Access Compliance Report

Public Rights-of-Way

Intersection ID: 30548	Main Street: SOUTH_BV	Cross Street: CAROLINA_PAVILION_DR_S	Location: SW
ADA ID: 50191B8DD427	Ramp Type: Perp	Initial Pass/Fail: Fail	Overall Compliance: No
		Severity Score: 22.5

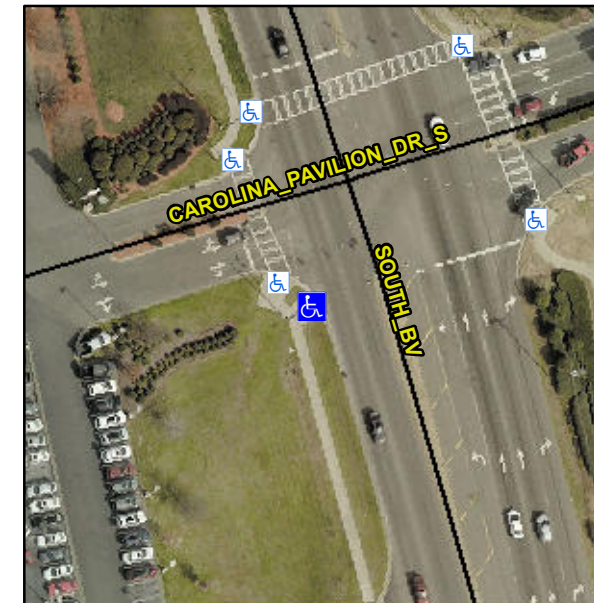
Not Found, R304.5.1, R304.2.2, R304.5.3

Compliance	Description	Data	Compliance	Description	Data
N/A	Ramp Length (in)	132.0	No	Ramp Slope (%)	8.8
No	Ramp Width (in)	47.0	No	Ramp XSlope (%)	4.0
N/A	Flare Type LT	N/A	N/A	Flare Type RT	N/A
N/A	Flare Slope LT (%)	N/A	N/A	Flare Slope RT (%)	N/A
N/A	Flare Traversable LT?	N/A	N/A	Flare Traversable RT?	N/A
N/A	Landing Length (in)	N/A	N/A	DWS Provided?	N/A
N/A	Landing Width (in)	N/A	N/A	DWS Contrast?	N/A
N/A	Landing Slope (%)	N/A	N/A	DWS Length (in)	N/A
N/A	Landing X Slope (%)	N/A	N/A	DWS Full Width?	N/A
N/A	Landing Curb? (Y/N)	N/A	N/A	DWS Offset (in)	N/A
N/A	Shared Landing?	N/A			
N/A	Gutter Ponding?	N/A	N/A	Gutter Slope (%)	N/A
N/A	Gutter Lip Ht (in)	N/A	N/A	Gutter X Slope (%)	N/A
N/A	Painted X Walk1?	No	N/A	Painted X Walk2?	N/A
	X Walk 1 Direction	To E		X Walk 2 Direction	N/A
N/A	X Walk 1 Width (in)	N/A	N/A	X Walk 2 Width (in)	N/A
	X Walk 1 Slope (%)	1.5		X Walk 2 Slope (%)	N/A
	X Walk 1 X Slope (%)	1.4		X Walk 2 X Slope (%)	N/A

Remove & Replace Entire Ramp.
